ACENERGY PTY LTD
Yanco Battery Energy Storage System
MODIFICATION APPLICATION

Project number: 223155

9 February 2026

Document Reference: 223155_ R01 MOD RevA

Figure 1 - Approved Development footprint (Appendix 1 of the consent)
APPENDIX 1 GENERAL DEVELOPMENT LAYOUT

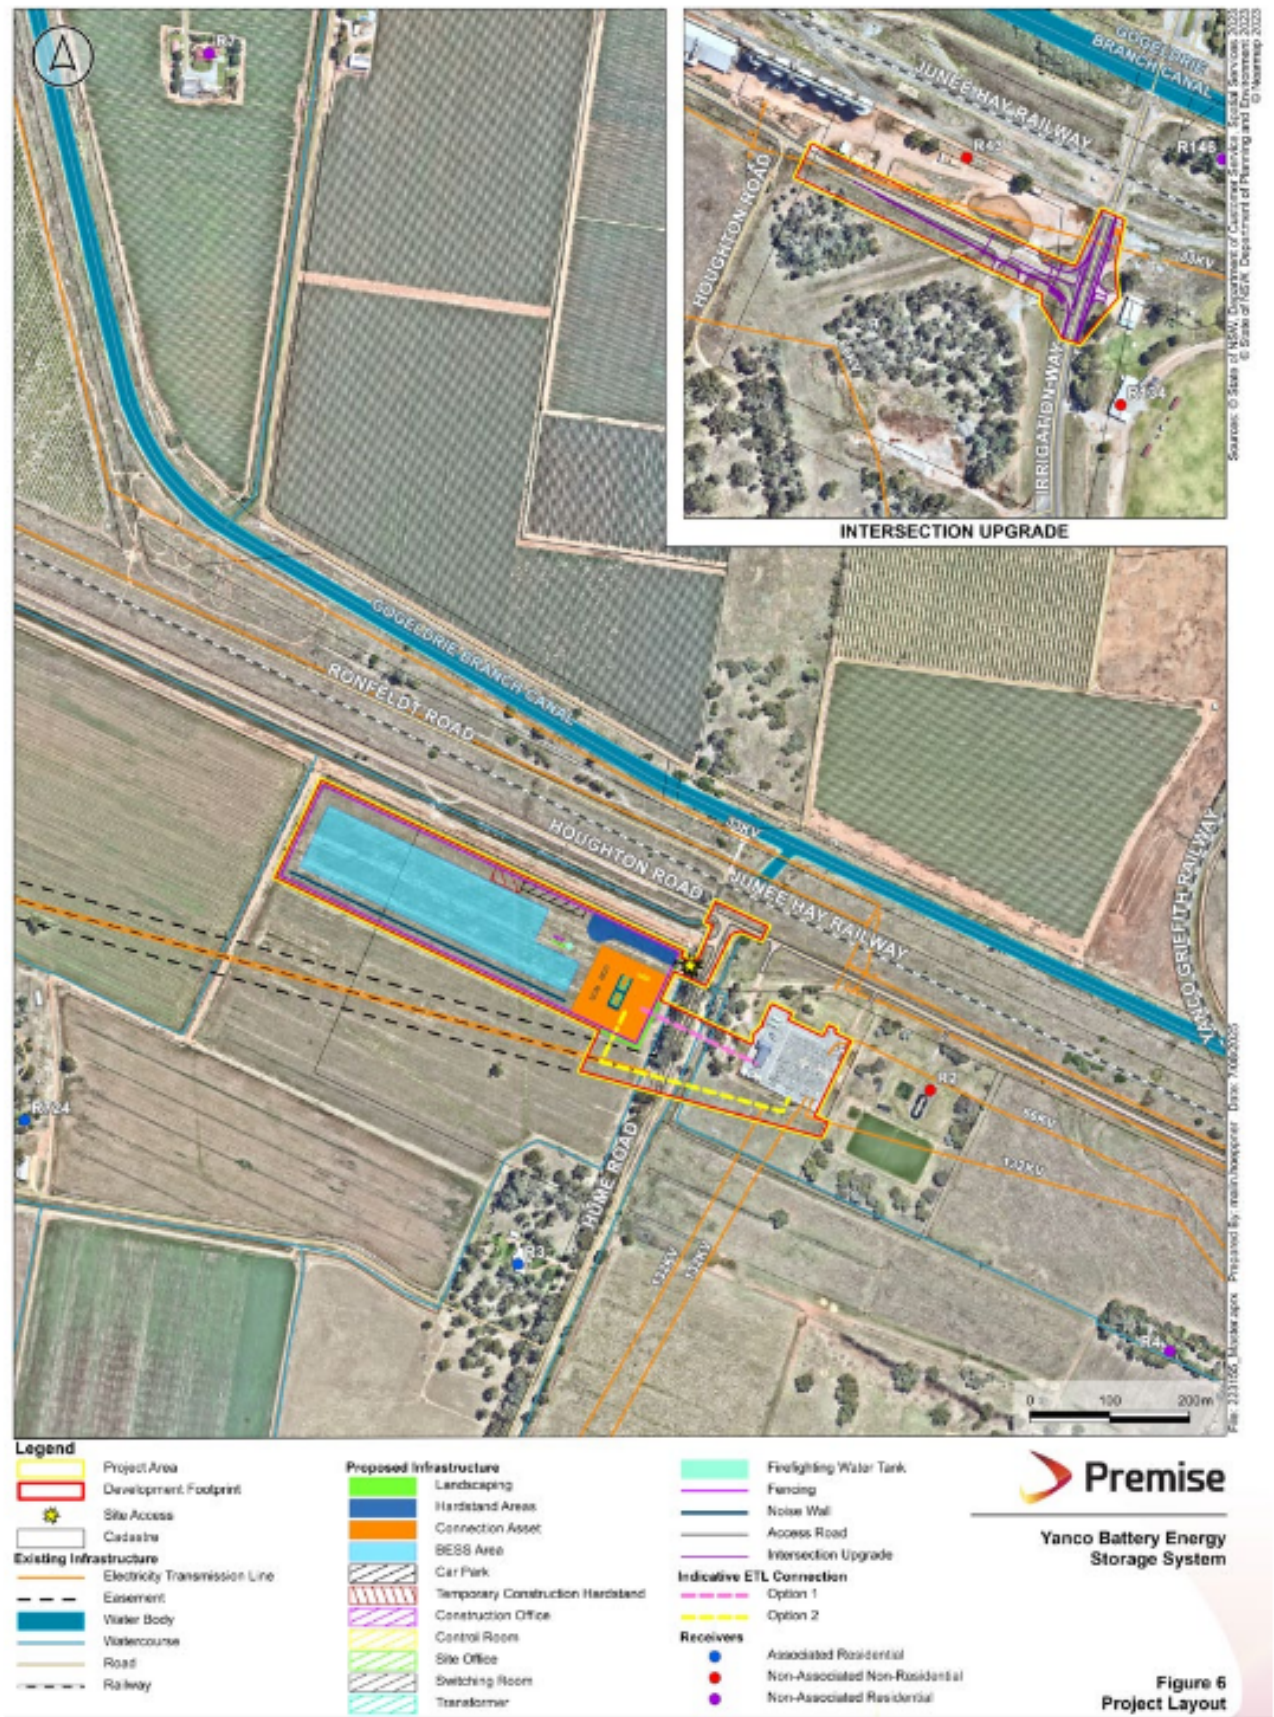
Details of the approved project are summarised in **Table 1** and the approved development layout is illustrated in **Figure 1**.

Figure 6
Project Layout

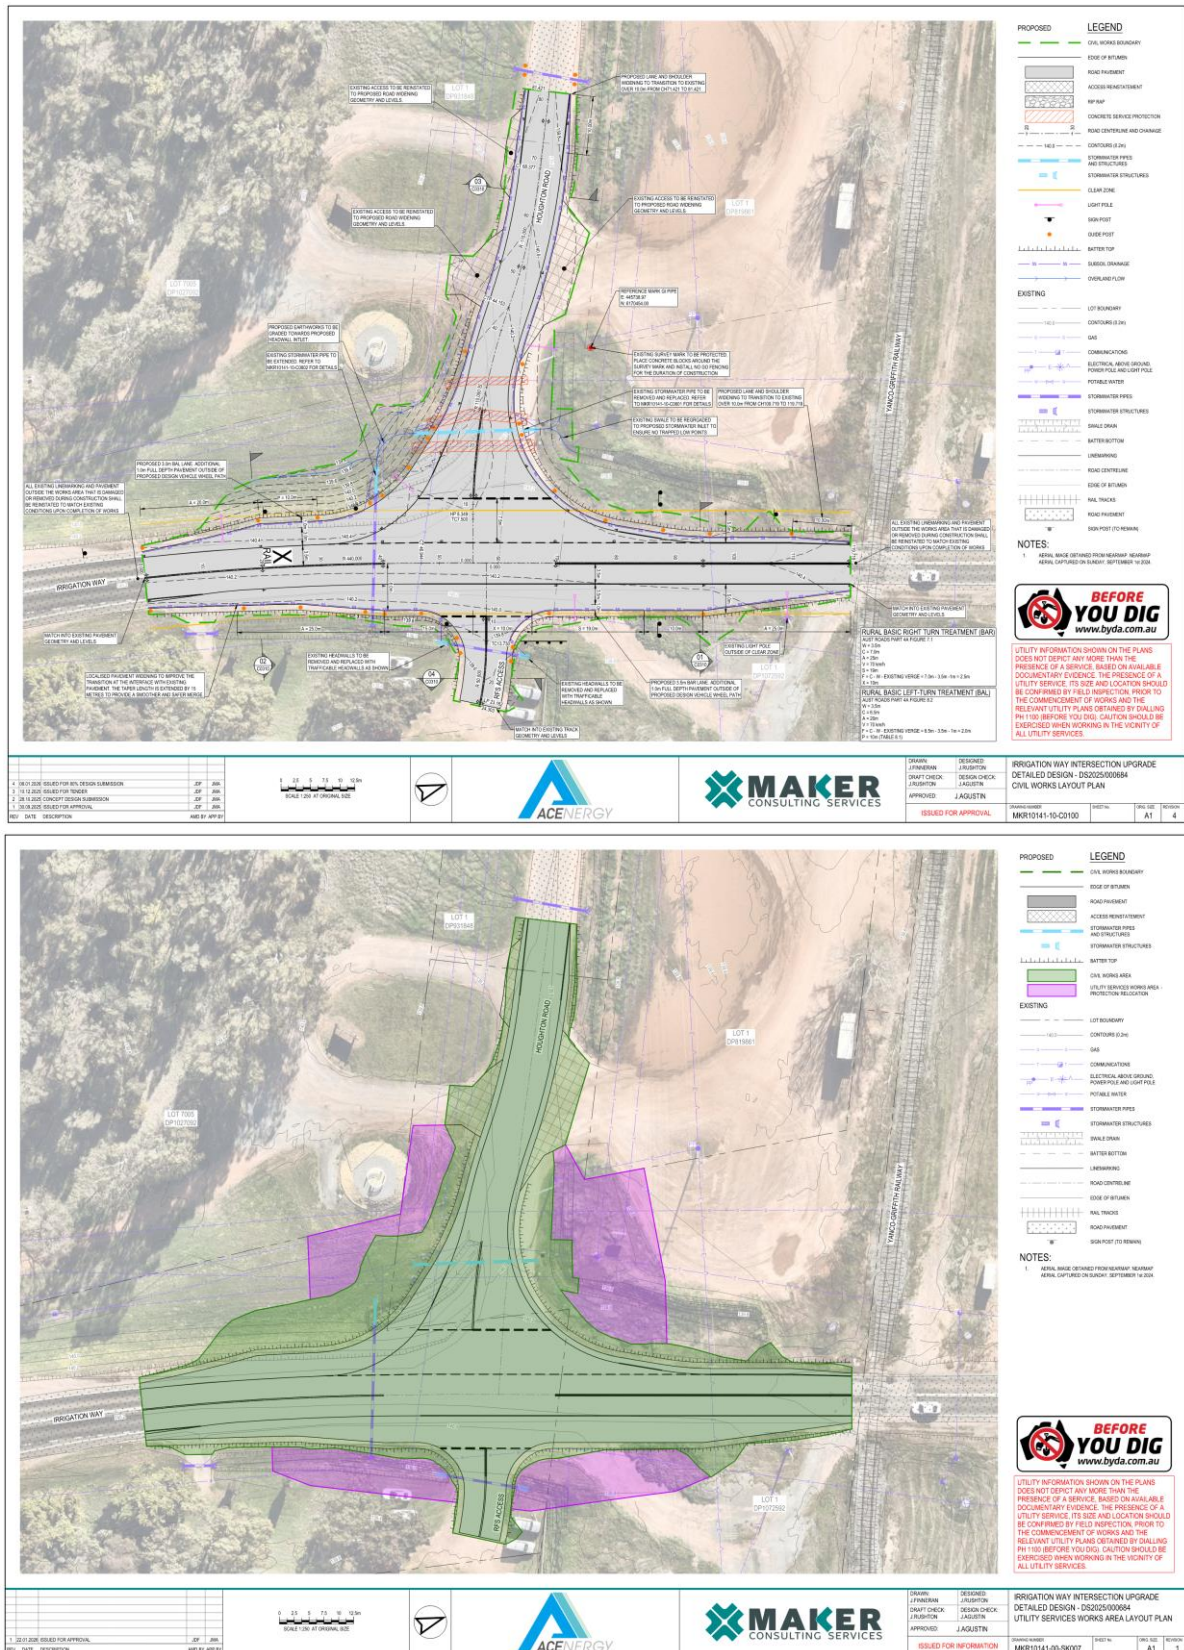
The third change is similar to the first two, representing minor changes to the site access design reflect the progression of detailed design with respect to the alignment of the underground electricity transmission line connecting to the Transgrid substation. The extent of change is very minor and does not result in any changes to the extent of the development footprint. There is no change to the construction approach for the transmission line, which will continue to be underground via horizontal directional drilling. Again, the motivation for the modification is to ensure consistency between the detailed design extents and the final design plans. The extent of the change is reflected in Figure 6.

The fourth and final change is to provide an approved site access point within the development footprint to provide access to the Yanco Substation directly from Houghton Road. This additional area is approximately 2,800 m². The inclusion of a nominated site access point to the Yanco substation has been provided at the request of Transgrid, who will be completing the substation augmentation works necessary to connect the battery, and who will be relying on the terms of this consent to carry out these works. The site access point is the existing site access to the substation and does not require any upgrade works as it currently accommodates light vehicles and heavy vehicles up to 19 m in length. Vehicles entering the substation would be limited to up to 19 m in length. The extent of the change is reflected in **Figure 6**.

- > Modify the definition of the development provided in the EIS and consent to include reference to this modification report: Yanco BESS Modification Application dated 9 February 2026.
- > Update the figure provided in Appendix 1 of the consent (General Development Layout) (refer to **Figure 6**).
- > Update the figure provided in Appendix 3 of the consent (Road Upgrades) to include a revised road upgrade design (refer to **Figure 7**)

Figure 7 – Update to Appendix 3 (Road Upgrades)

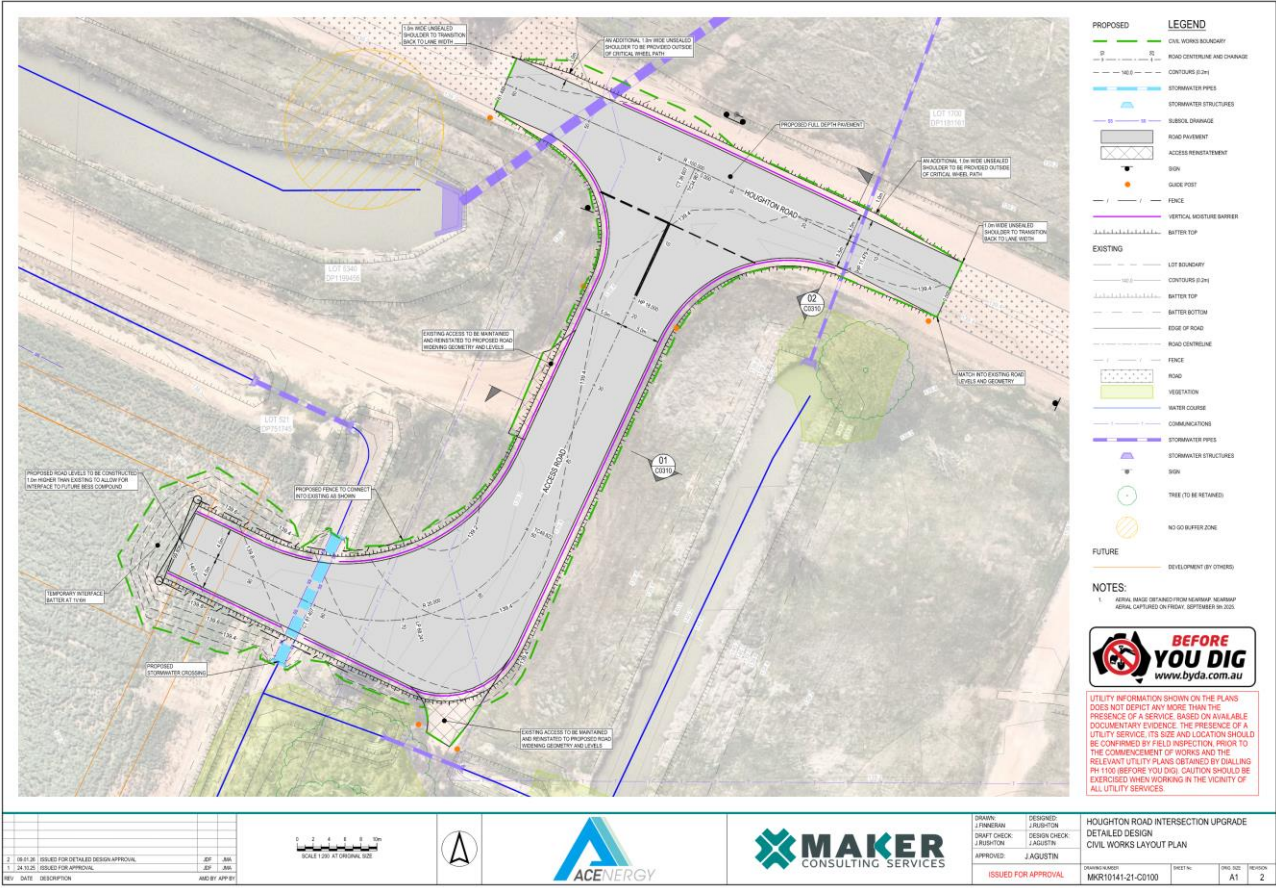
The first change relates to changes to the Irrigation Way/Houghton Road intersection upgrade impact assessment area. As detailed design and investigations have occurred, including the process of submitting a Works Authorisation Deed (WAD) from TfNSW, necessary changes are proposed to accommodate the area of the required road upgrades at the intersection of Irrigation Way and Houghton Road. In the south of the design area, additional impacts are required with respect to accommodating drainage, adjustment to services and tie-in of the upgrades to the existing formation. These changes represent a small area of no more than 315 m² to the original intersection upgrade area. In the north-western extent of the upgrade area, an additional area of disturbance is proposed to accommodate potential services adjustments (approximately 330 m²). The proposed changes are to ensure consistency between the approved development footprint and the area subject to the WAD, to satisfy TfNSW requirements. The extent of the change is reflected in **Figure 7**.

The second change is similar to the first, representing minor changes to the development footprint to reflect the progression of detailed design with respect to the Houghton Road/Hume Road intersection upgrade works and site access from Hume Road. The extent of change is very minor, around 195 m² in total, and results in negligible changes to the extent of the development footprint. Again, the motivation for the modification is to ensure consistency between the detailed design extents and the approved plans. The extent of the change is reflected in **Figure 7**.
